HIGHWAYS IMPROVEMENT GROUP (HIG) Scheme Appraisal Form

REFERENCE TITLE	*Compton Speed limit changes*
Month Raised	*August*
Date of Initial Response	*August*
Officer Responsible	*Gareth Dowding*
Requested By	*Compton Parish Council*
Estimated Cost (Low/Medium/High)	*HIGH*
Officer Time (Low/Medium/High)	*HIGH*
Project Duration (Low/Medium /High)	*HIGH*

Scheme Location Plan / Map:

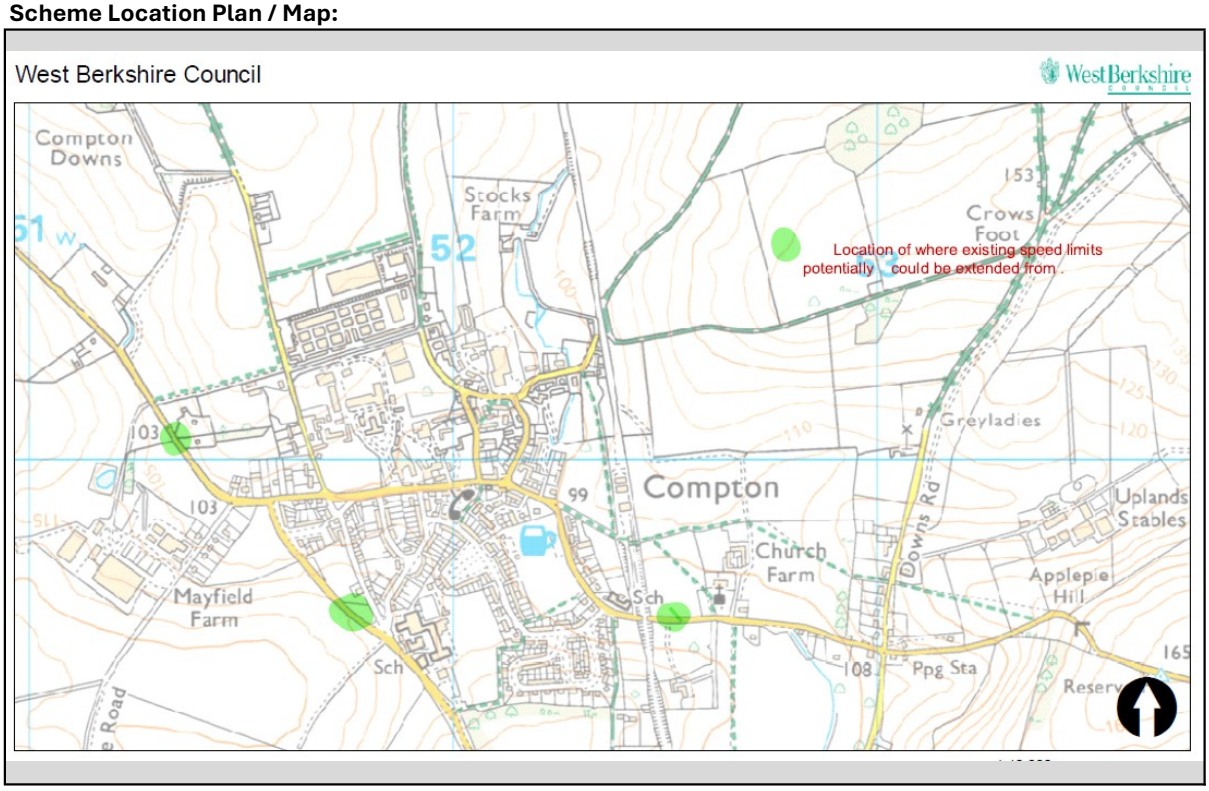
As explained to the Parish at the Parish meeting this was presented to officers as just changing a speed limit sign and moving the entry point will not necessarily change driver behaviour and a speed limit change may require additional works as well to support the change. The cost of these additional works can be as much as the speed limit change works so it is advisable to look at non speed limit changes first with works such as VAS, signaging and enhance lining.

Put these works on the list for 27/28 and assess signing and lining works works in advance of any speed limit changes and to include enhanced gateway features.
